Urban Design Assessment

GMU Ref. 16051

Amended Plans for Mixed Use Development at
121-133 Burwood Road & 36-40 Railway Parade, Burwood

10 March 2016

Figure 1. A snap shot from the 3d model pdf (Source: Dickson Rothschild Design)

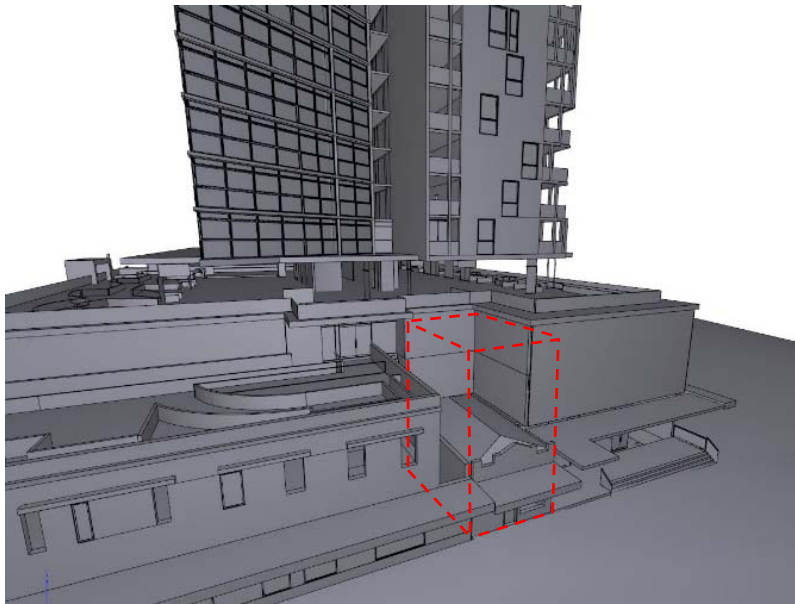
This is still an unresolved issue, which was raised in the previous GMU's report. It is GMU's understanding that the site at No.34 Railway Parade will be isolated when the proposal is built; however, it can redevelop to up to 9m in height (podium top). Possible accesses from the proposed podium top to the potential development within No.34 Railway Parade should be avoided. The red dashed line in Figure 1 shows how close the tower form will be from the proposed podium top to the potential 9m built form within the isolated site. The applicant should take this into account and ensure an adequate built form transition as well as avoid any potential safety, and access issues to this site.

Figure 4. An extract of the amended ground floor plan (Source: Dickson Rothschild Design)

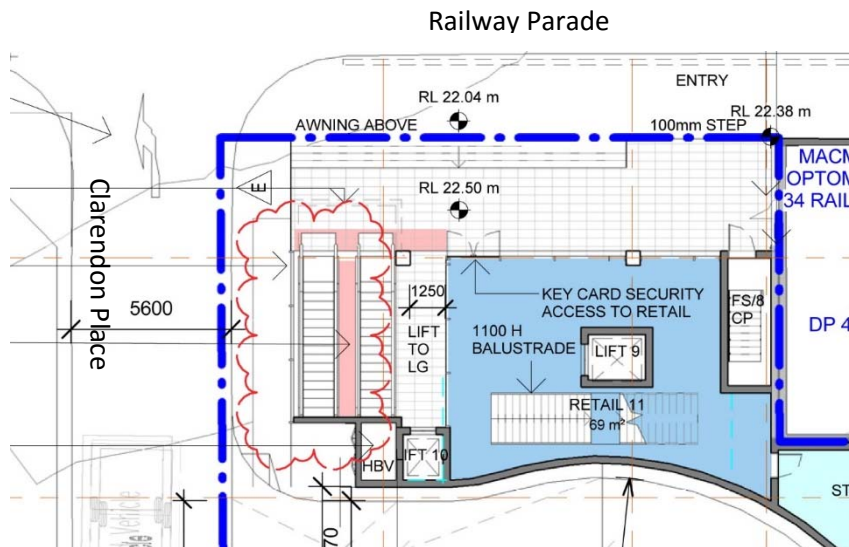
There is still a concern with the western edge activation, especially the corner of Railway Parade and Clarendon Place. The amended scheme proposes a new glass screen to the corner (to the side of the proposed escalator in Figure 4 below); however, this does not radically transform the inactive nature of the rest of the street. While it assists it is the treatment of all the vehicular opening that should be minimised to improve the character of this elevation. As proposed, almost half of the proposed western edge along Clarendon Place is either inactive or occupied by vehicular entries, as shown in Figure 5. The applicant should adjust the design further to promote more active use to this corner and the rest of the elevation.
